ADDENDUM # 01

Blue Ridge Community College

One Stop - Renovation Phase II

SCO ID# 18-18892-01A

A1 FIRST FLOOR PLAN
1/8" = 1'-0"

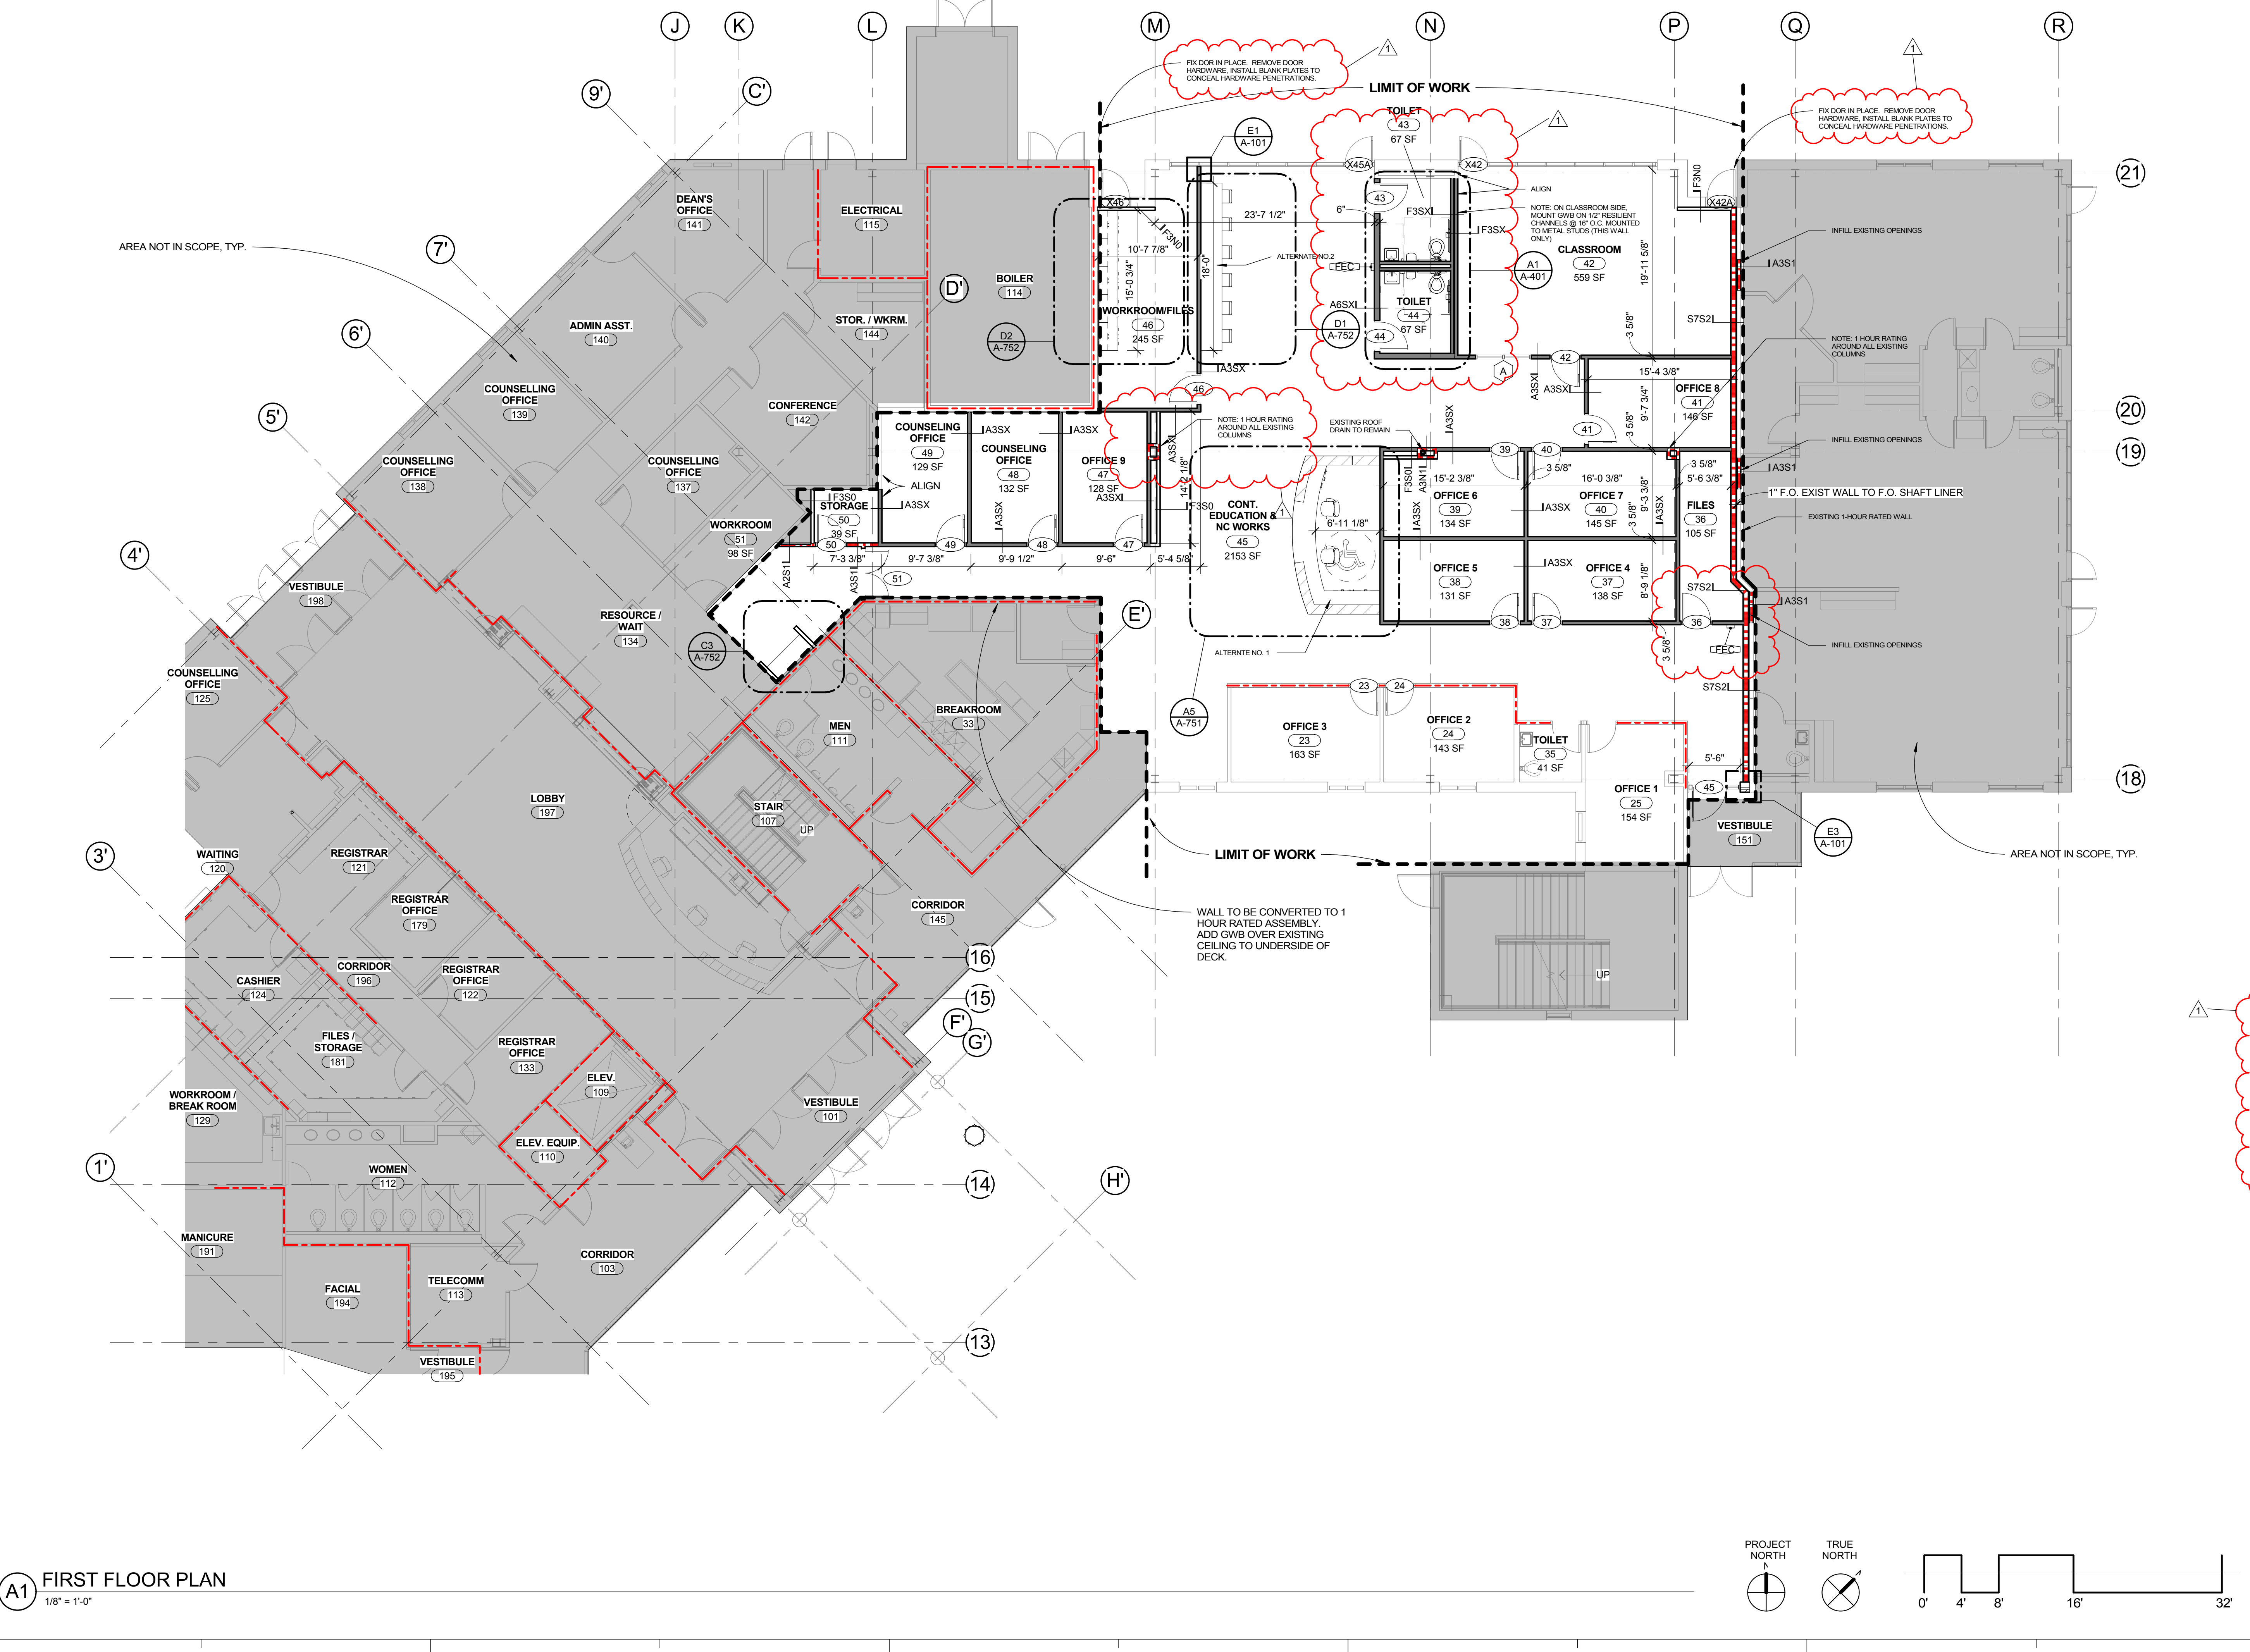
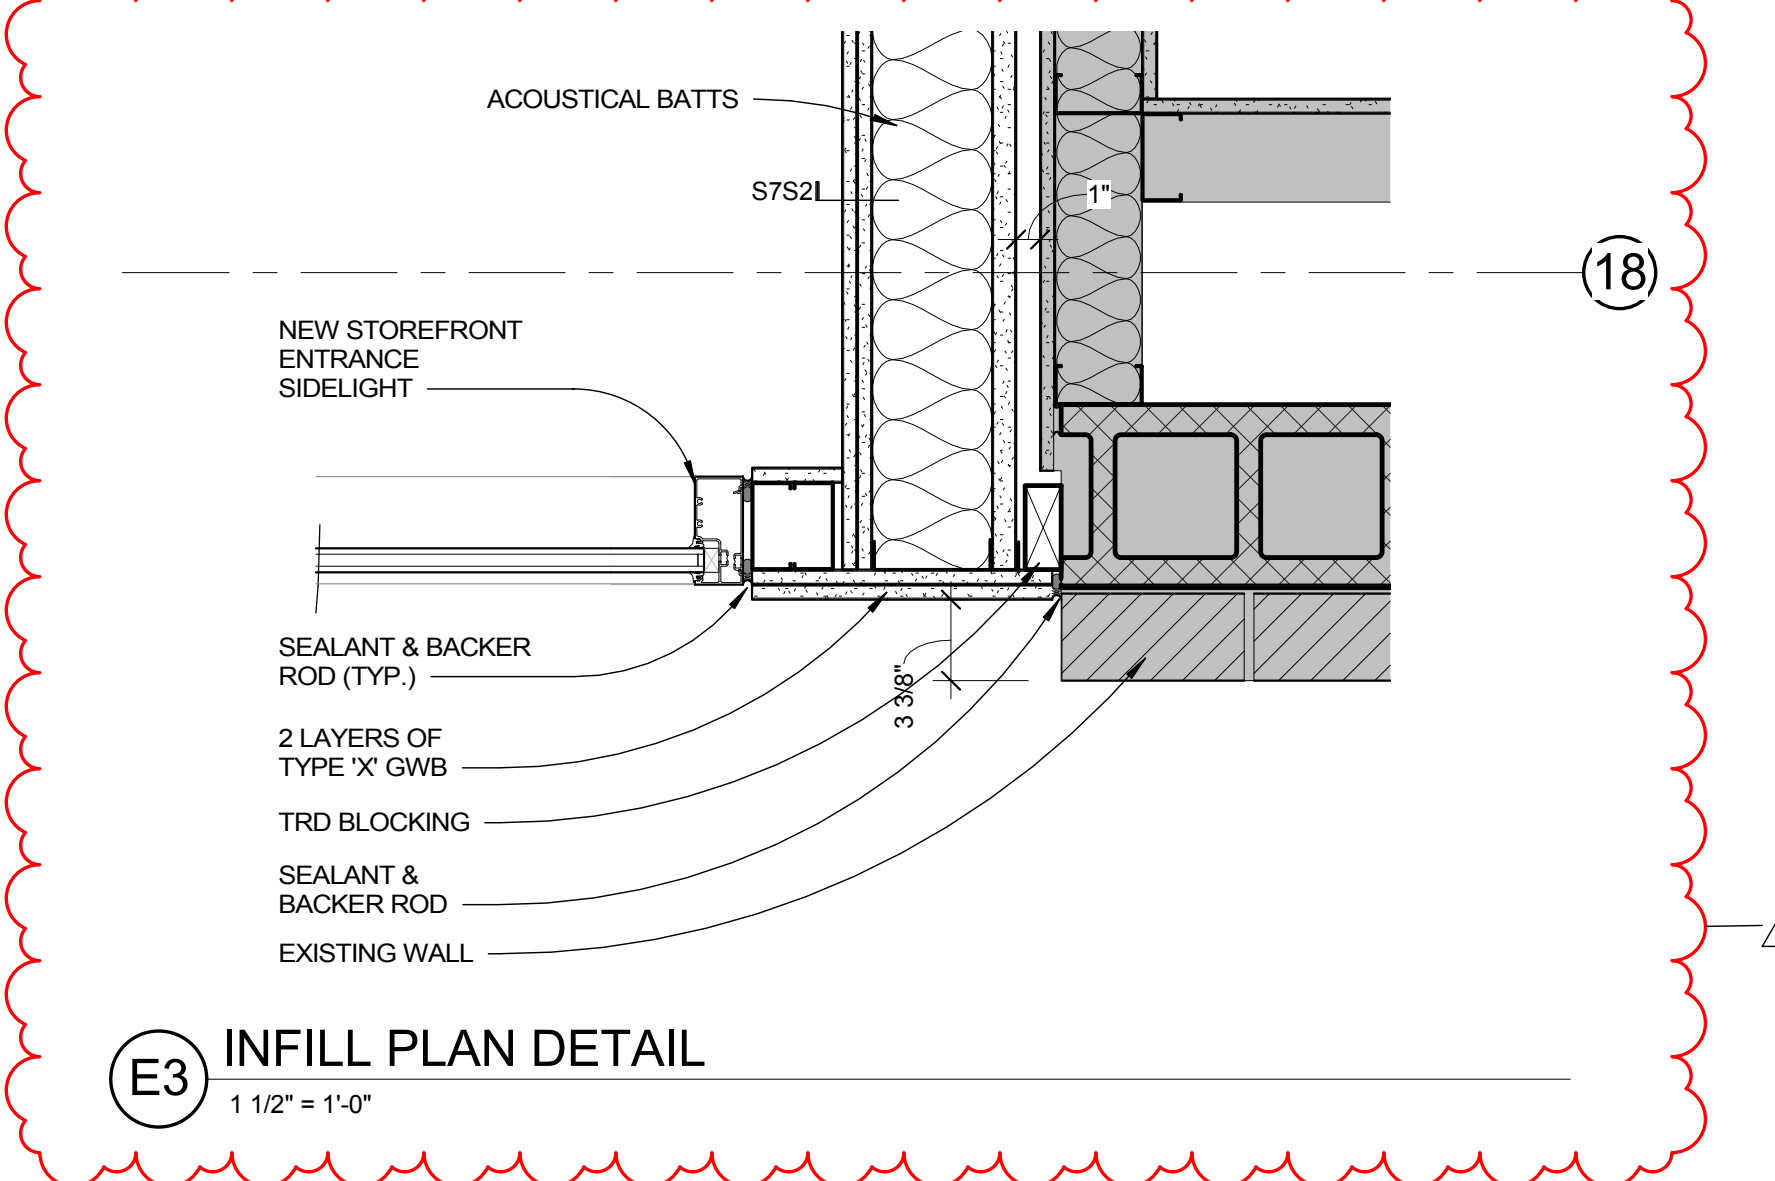
- 3.1 G-101 – LIFE SAFETY PLANS: Updated temporary barrier information.
- 3.2 A-002 – PARTITION TYPES: Updated partition type for walls at restrooms to extend to deck.
- 3.3 A-101 – FIRST FLOOR PLAN: Provided clarity for renovated components, wall types.
- 3.4 A-401 - ENLARGED PLANS: Updated restroom accessories information
- 3.5 A-601 – DOOR SCHEDULE, DOOR TYPE LEGEND & FRAME TYPES: Updated door information.
